SUBJECT: APPROVAL OF CHANGE ORDER #3 RADCLIFF ELEMENTARY

Change Order

PROJECT (Name and address):
Renovation to Radcliff Middle School -
Phase I
1145 S. Dixie Boulevard
Radcliff, Kentucky 40160

CHANGE ORDER NUMBER: 003

BY: _____ DATE: _____ SUBJECT: **RADCLIFF AVM** SHEET NO: _____ OF: _____
CHKD BY: _____ DATE: _____ **RTU SUPPORTS @ GYM** JOB NO: **0035**

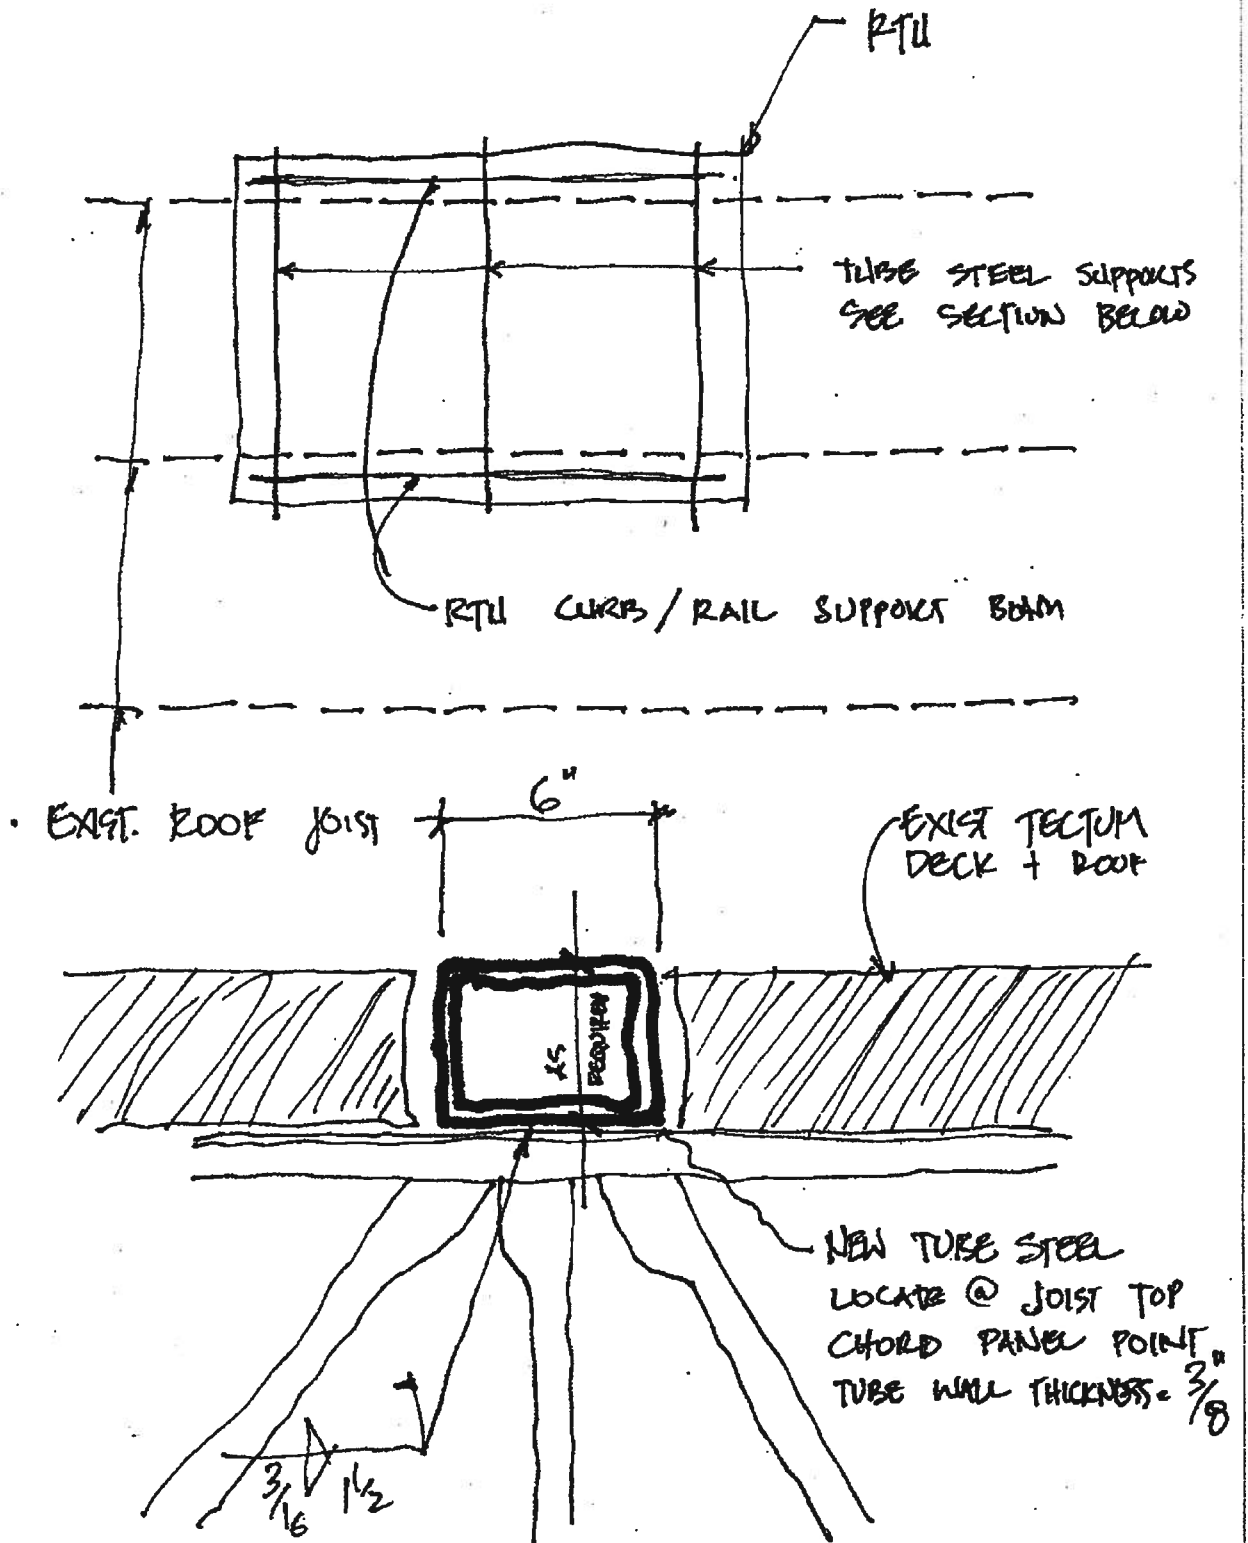
The attached sketch shows the addition of three (3) tube steel supports to be added at the roof to support the new RTU's. Channels are to be cut into the Tectum deck and roofing to allow for the installation of the tube steel supports.

It is probably necessary to weld a 1/4" thick plate to the bottom of the tube steel and let that plate be 3" wider than the tube steel to create a 1.5" wide shelf at each side of the tube steel to catch the Tectum deck. I just thought of that after I scanned in the sketch so you need to add that in.

We talked about support for the RTU's we're adding at the gym. I forgot to ask you about that this morning. Also, do you want the new work in the gym painted out flat black?

Rick,
Structural detail at new Gym rooftop units is forthcoming.
Yes, flat black will be fine.
